HISTORIC PRESERVATION COMMISSION
REGULAR MEETING
MAY 28, 2020
ASSEMBLY HALL & ZOOM MEETING PLATFORM
395 MAGNOLIA ROAD
PINEHURST, NORTH CAROLINA
4:00 PM

To: Historic Preservation Commission
From: Peter Hughes, Senior Planner
CC: Darryn Burich, Planning and Inspections Director
Kelly Brown, Administrative Specialist
Date: June 18, 2020
Subject: **Major COA Request for 25 Barrett Road (COA-2020-00064)**

To: Historic Preservation Commission
From: Peter Hughes, Senior Planner
CC: Darryn Burich, Planning and Inspections Director
Kelly Brown, Administrative Specialist
Date: June 18, 2020
Subject: **Major COA Request for 15 Medlin Road (COA-2020-00067)**

To: Historic Preservation Commission
From: Peter Hughes, Senior Planner
CC: Darryn Burich, Planning and Inspections Director
Kelly Brown, Administrative Specialist
Date: June 17, 2020
Subject: **Major COA Request for 120 Saville Row (COA-2020-00069)**

Submitted Site Plan

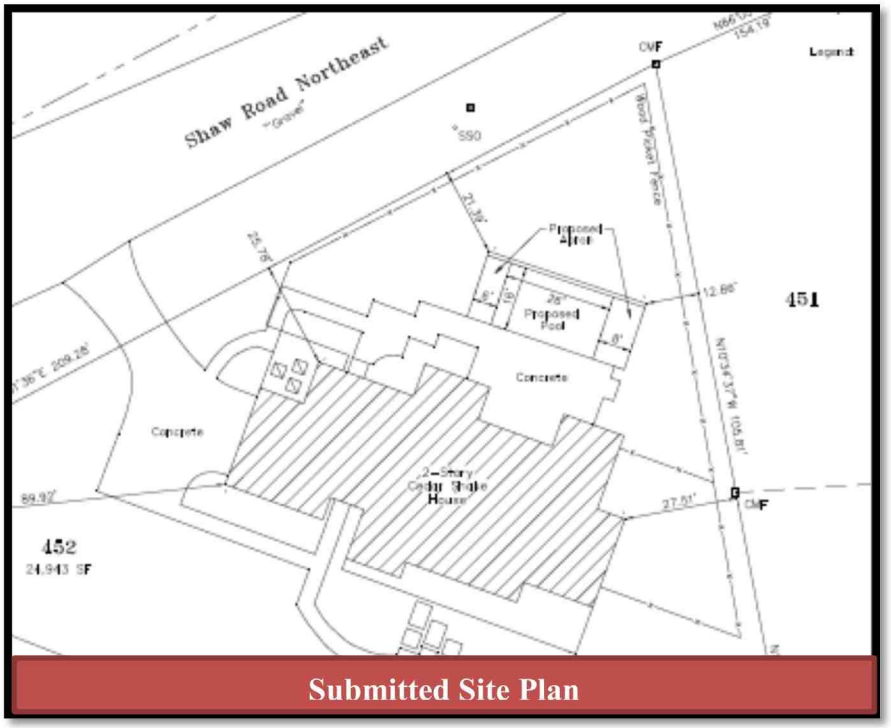
The applicant is locating the pool in the rear yard and incorporating new pathways to shield the swimming from public view and incorporate it into the existing landscape of the home. Pools exist throughout the District and it appears from the site plan and proposed location of the pool, that this pool will have the least if any adverse impact on the Historic District Landscape.

The applicant is proposing to locate the swimming pool in the rear yard located adjacent to a private drive/alley that is heavily screened. Based on the site plan and the site visit made by staff the swimming pool appears to be located in a manner that it will not be easily visible from the street.

Submitted Site Plan

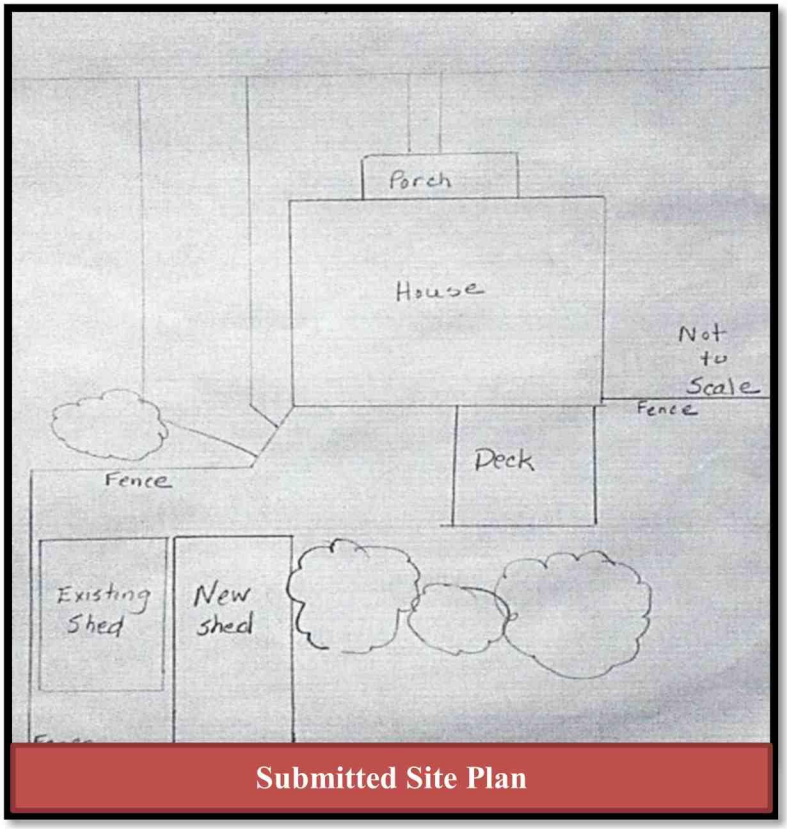
The proposed location of the new accessory structure will be located in the rear yard of the lot.

Proposed location is just left of existing shed

Proposed Accessory Building Right Elevation

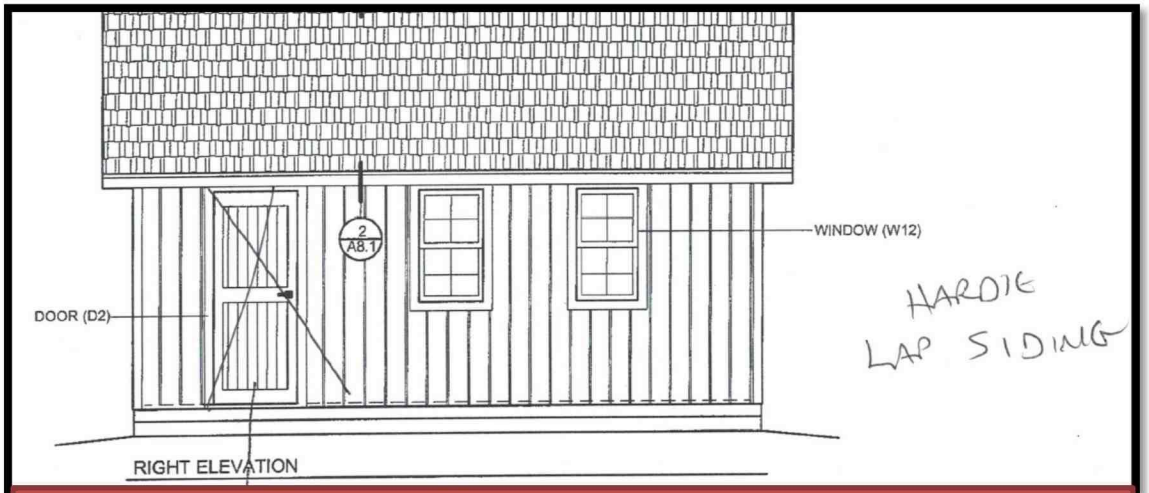
The proposed 4 over 4 windows are a style used throughout the Historic District, the primary structure features 6 over 6 windows. While the proposed windows are not an exact match to the

windows featured on the home, the proposed location of the windows on the right elevation and proposed location of the building in the rear yard would shield them from public view.

Submitted Site Plan

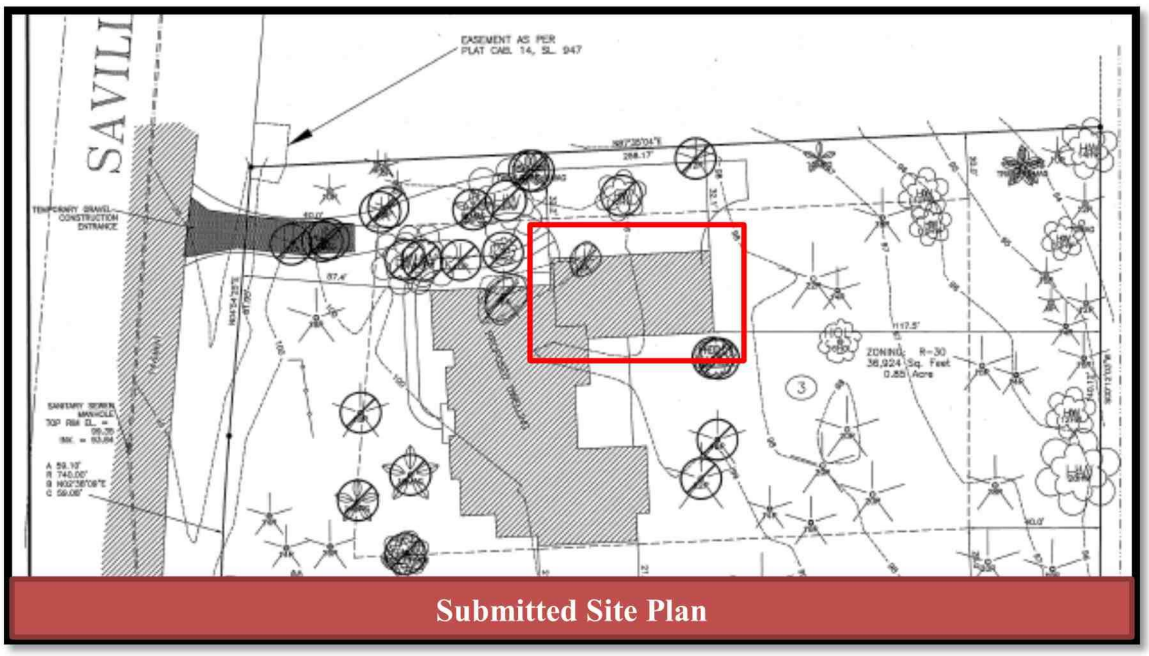
The proposed garage is not front facing, but may be visible from the street.

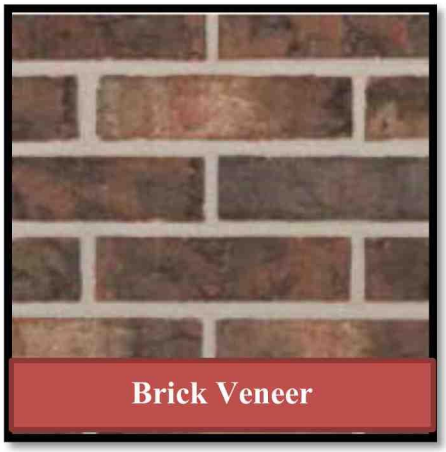
The proposed siding material is stucco and brick veneer. The front of the proposed structure will feature stucco and brick while the rest of the structure will be brick veneer. Both the materials are similar to material utilized on other homes within the Historic District.

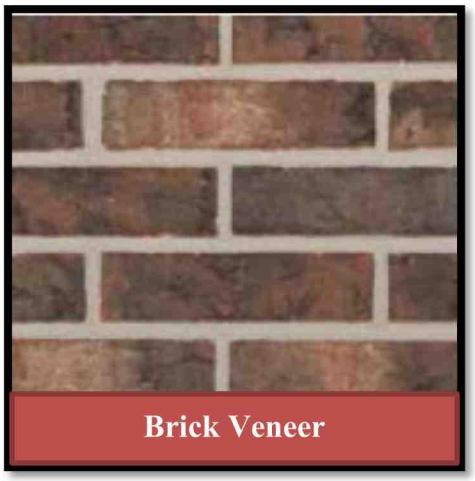
The proposed foundation material is a brick veneer from the triangle brick company. The proposed brick foundation appears to be similiar with other structures within the Historic District and is an appropriate material according to the Historic District Guidelines.

Garage Door from Submitted Elevation

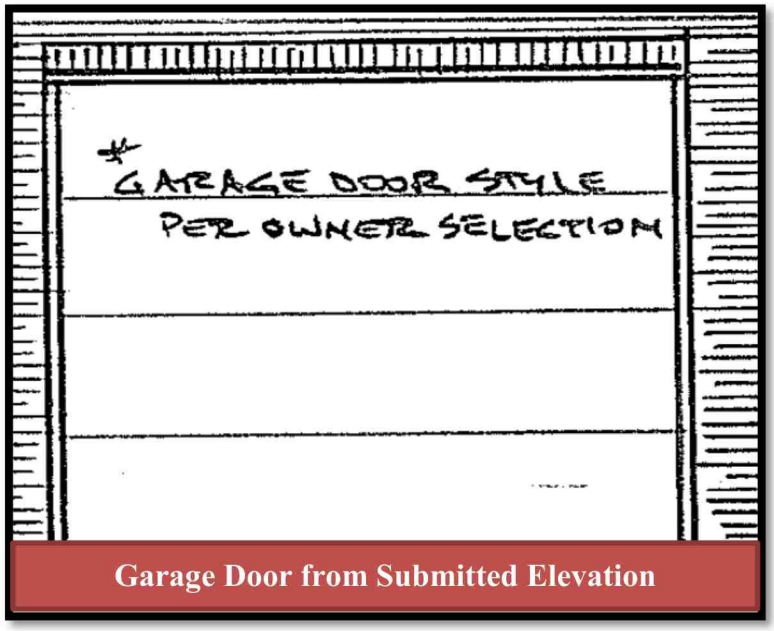
The proposed garage door is a Wayne and Dalton door. The elevations shows that the homeowner is to make the final choice on style. In the past the Commission has preffered for all exterior details to homes to be final prior to approval, however staff can address garage doors through the minor COA process if necessary.

Submitted Door Sample

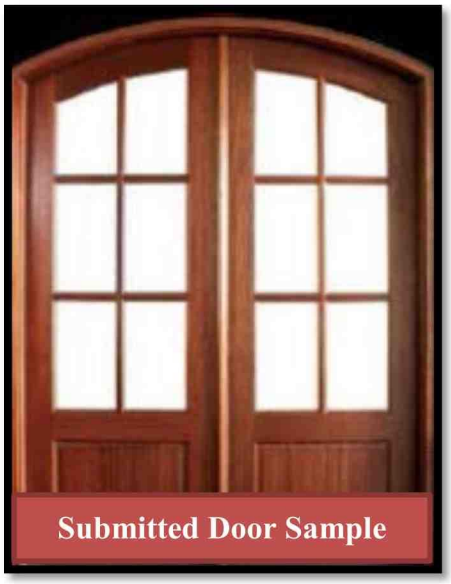
The applicant has indicated that the front door will be wood with glass panes. The material and chosen color of mahogany are compliant with the Historic District Guidelines.

Submitted Site Plan

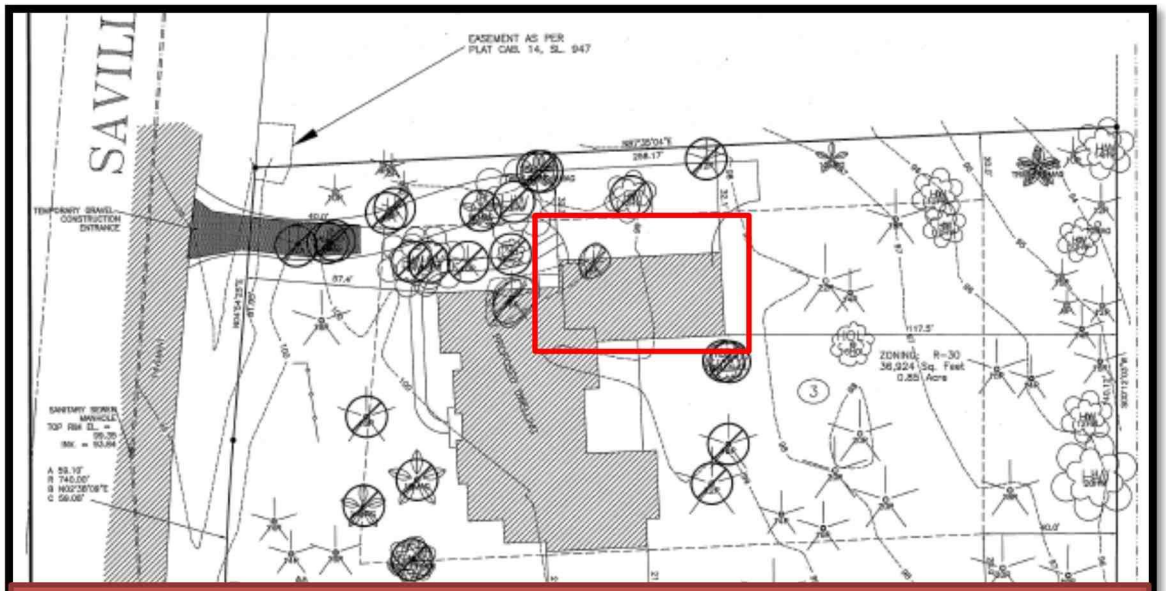
The proposed garage will be positioned on the left side of the home.

Front Elevation Roofline and Gutter To Be Made Flush

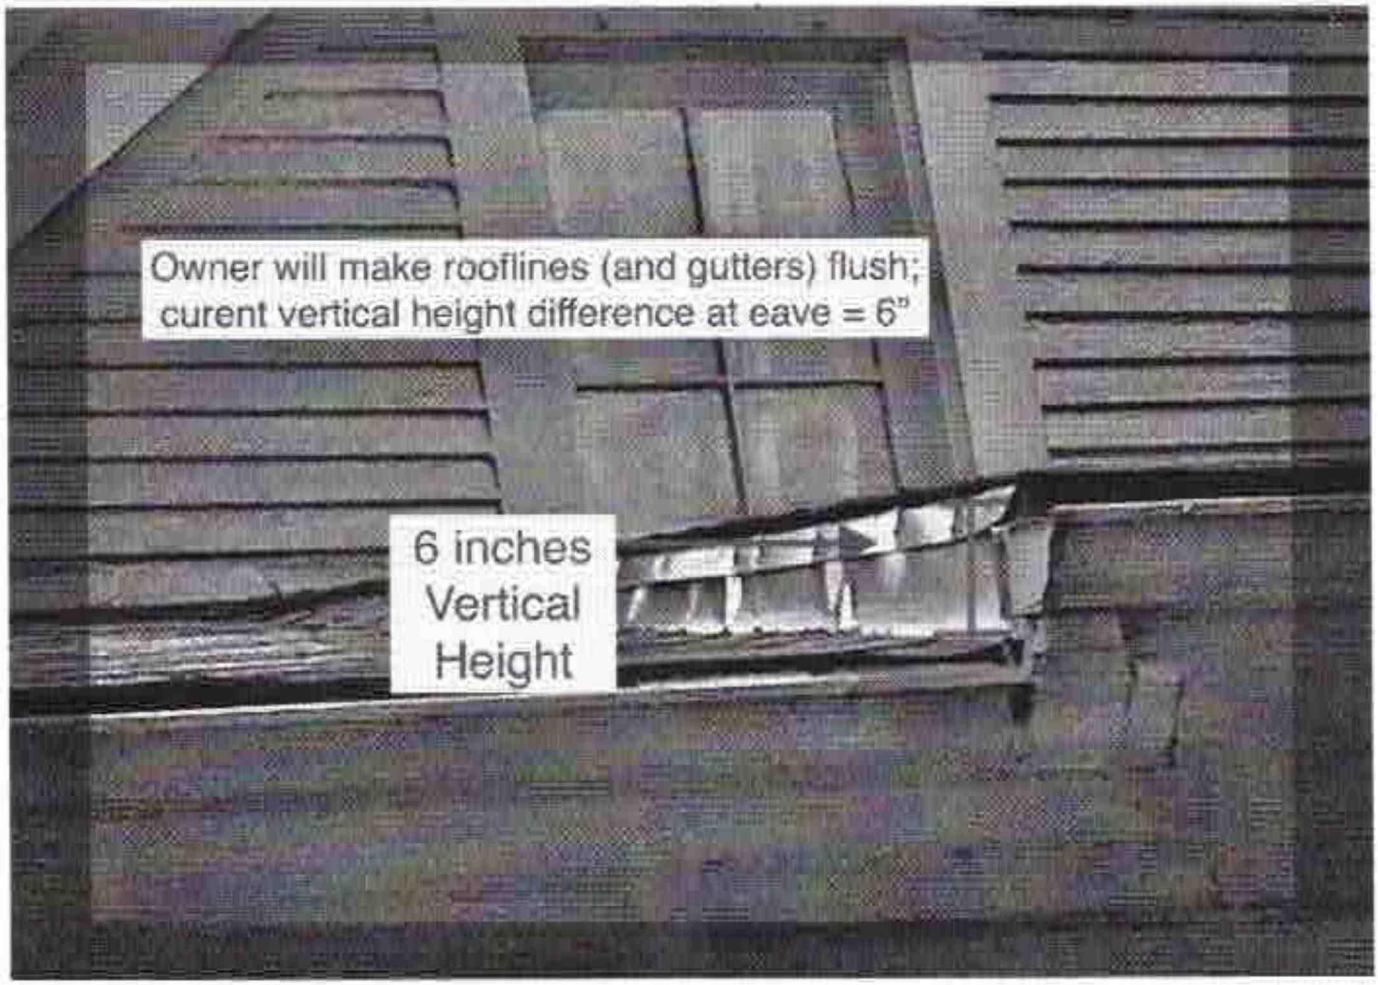
The applicant is proposing to raise the left side of the front roofline approximately 6 inches. The reason for this proposed change is to create a level and symmetrical roofline across the front elevation roofline.

The applicant's proposing to raise the existing roof line approximately 6 inches. The applicant has indicated in their application that realigning the roof will require rebuilding the right (east) section of roofing infrastructure. Realignment will require modification to the eave, rafter, collar, bracing, battens, sheeting, flashing, and shingles. The end result of the proposed change is an aesthetically seamless and symmetric roofline. The applicant is proposing this change to enhance the visual appeal of the house and to alleviate some water runoff issues created by the disjointed roof system. This proposed change would be compatible with the existing architecture and match other rooflines with the Historic District.
